In response to a portion of your request dated April 1, 1975, the Commission has issued the enclosed Amendment No. 17 to Provisional Operating License No. DPR-22 for the Monticello Nuclear Generating Plant. The amendment consists of changes to the Technical Specifications to be consistent with a recent NSP reorganization and to clarify the organization and role of the Safety Audit Committee (SAC).

AMENDMENT TO PROVISIONAL OPERATING LICENSE

Amendment No. 17
License No. DPR-22

SUPPORTING AMENDMENT NO. 17 TO PROVISIONAL OPERATING LICENSE NO. DPR-22

FIGURE 6.1.1

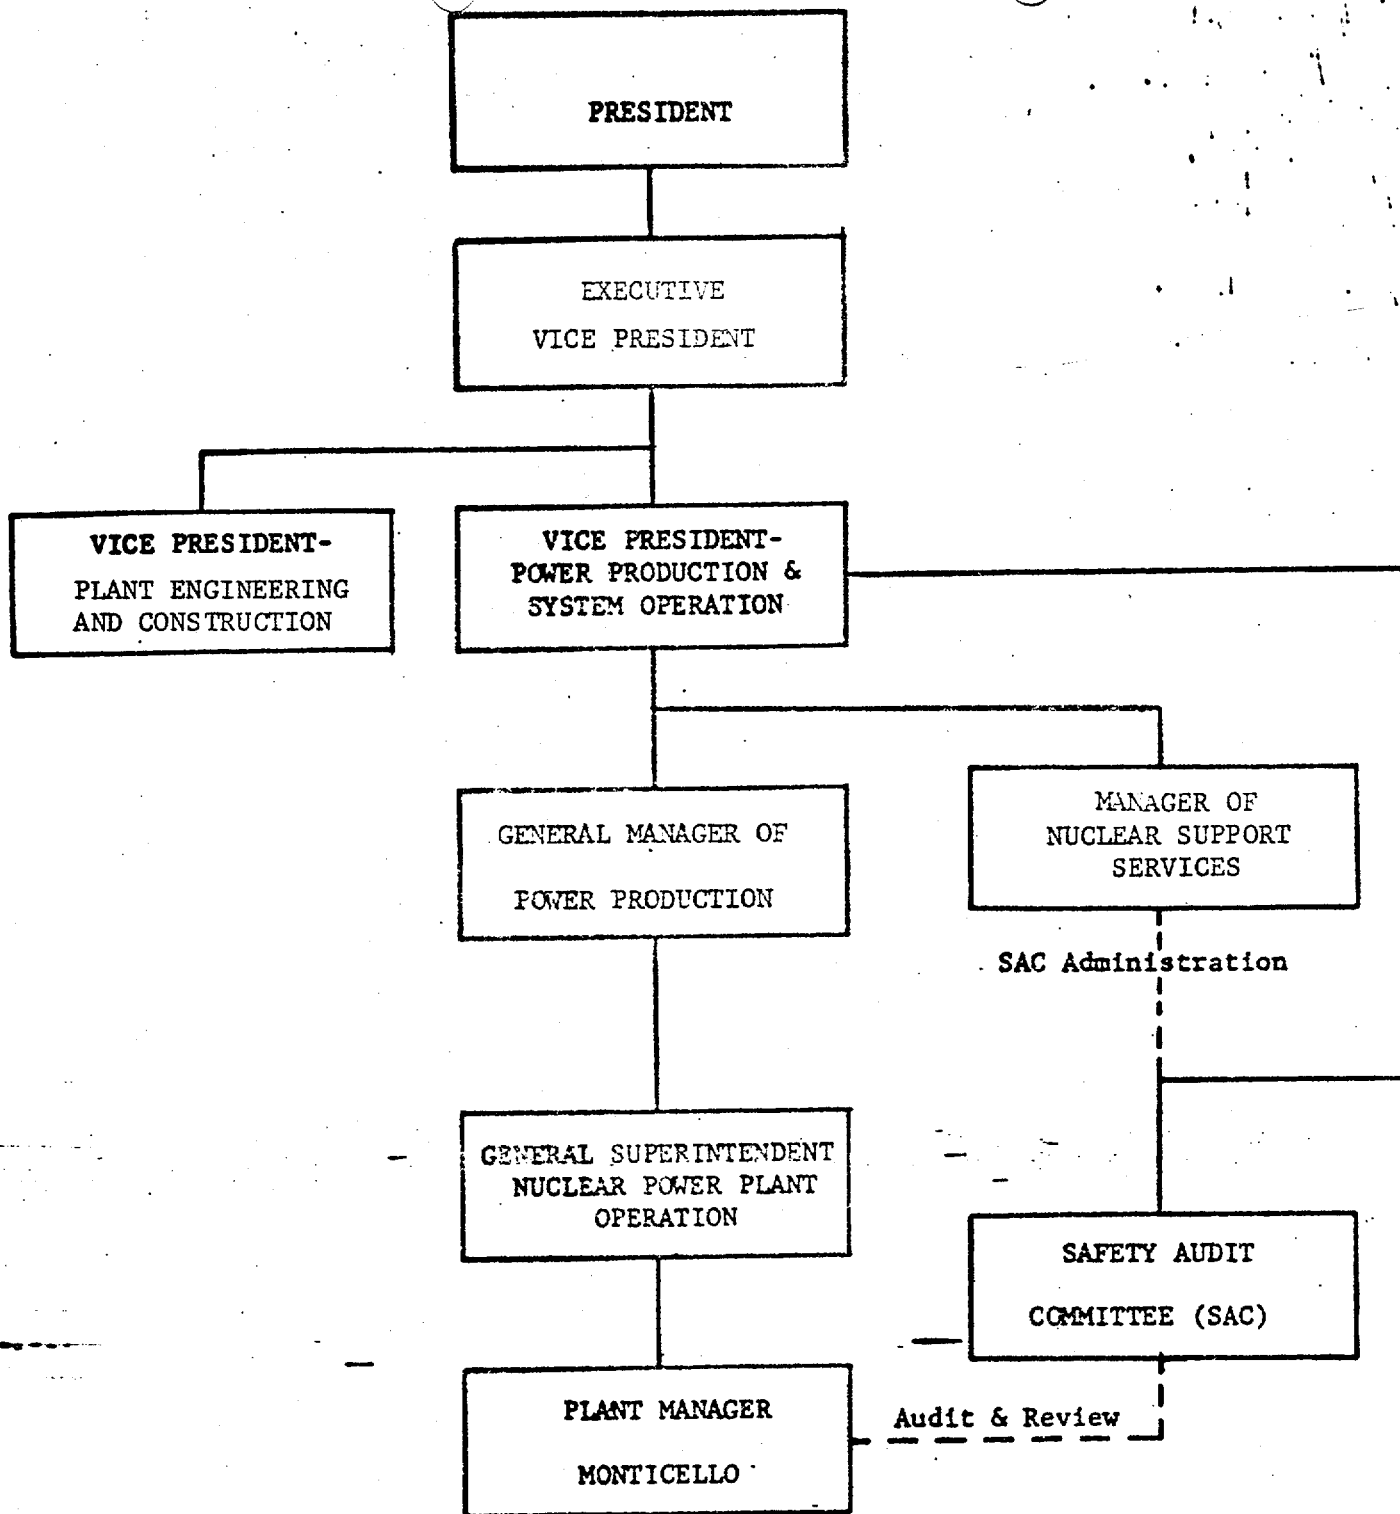
1. The replacement of the Group Vice-President - Power Supply by the Executive Vice-President. The original NSP Organization included three Group Vice-Presidents. In an effort to consolidate and provide

more effective functional division of organization responsibilities, two Executive Vice-Presidents, one for internal operations and one for external operations, were named to replace the three Group Vice-Presidents. The Executive Vice-President for Internal Operations is the officer depicted on Figure 6.1.1. We have concluded that such consolidation of the organization will not weaken the effectiveness of the organization with respect to nuclear safety and is therefore acceptable.

2. The title of Vice-President - Engineering has been changed to Vice-President - Plant Engineering and Construction to more accurately reflect his responsibilities within the new organization. The original position of Vice-President - Engineering included all engineering and construction functions. This change confines the engineering and construction responsibilities of the position to plant-oriented tasks. Responsibility for transmission lines and substations have been transferred to another position. We have concluded that this delineation of responsibility as reflected in the title change is acceptable.

3. The title Director of Nuclear Support Services has been changed to that of Manager of Nuclear Support Services. The lines of communication have been altered such that the Manager of Nuclear Support Services and the Safety Audit Committee now report directly to the Vice-President - Power Production and System Operation rather than the Executive Vice-President (formerly Group Vice-President).

The change in position title from Director to Manager of Nuclear Support Services is only a change in title and carries no change in responsibilities. The changes in lines of communication for the Manager of Nuclear Support Services and Safety Audit Committee reflect NSP's desires to consolidate the organization in such a manner that the Vice-President - Power Production and System Operation shall maintain direct cognizance of all nuclear and fossil activities. The NRC staff feels that this strengthens the NSP organization by providing direct communication to one individual who is responsible for all nuclear matters, thus effectively shortening the chain of command. The change is therefore acceptable.

4. The former title Manager of Power Production has been changed to General Manager of Power Production. The responsibilities of this position include management of operation and maintenance for all fossil and nuclear generating plants. The NRC staff has concluded that the change of title to more accurately reflect the amount of responsibility is acceptable.

FIGURE 6.1.2

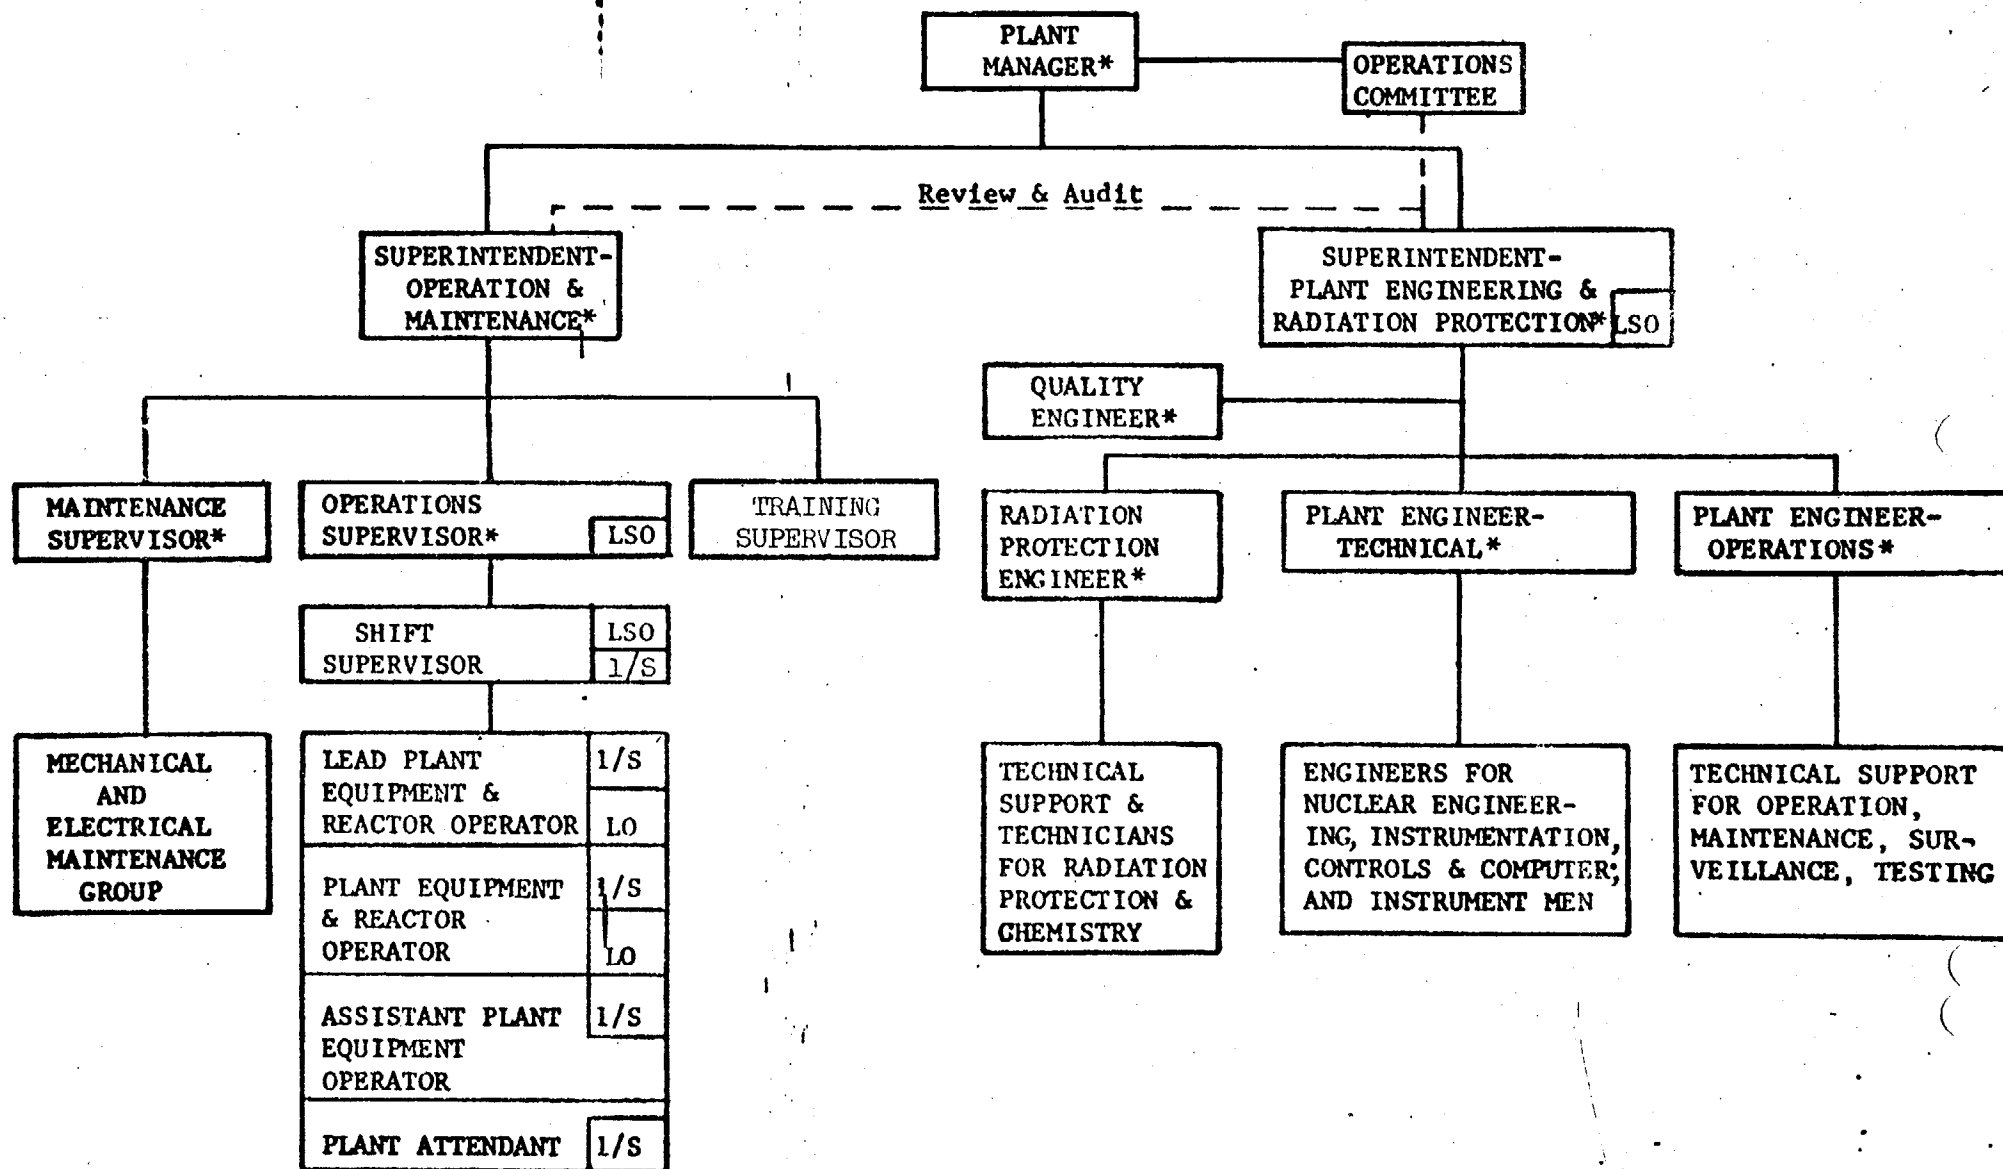
The change to the Monticello Nuclear Generating Plant Organization would consist of the addition of the position of Training Supervisor, who will report to the Superintendent - Operation and Maintenance. The Training Supervisor is responsible for conducting the Monticello Operator Requalification Program. We have concluded that the addition of this position will strengthen the organization and therefore is satisfactory.
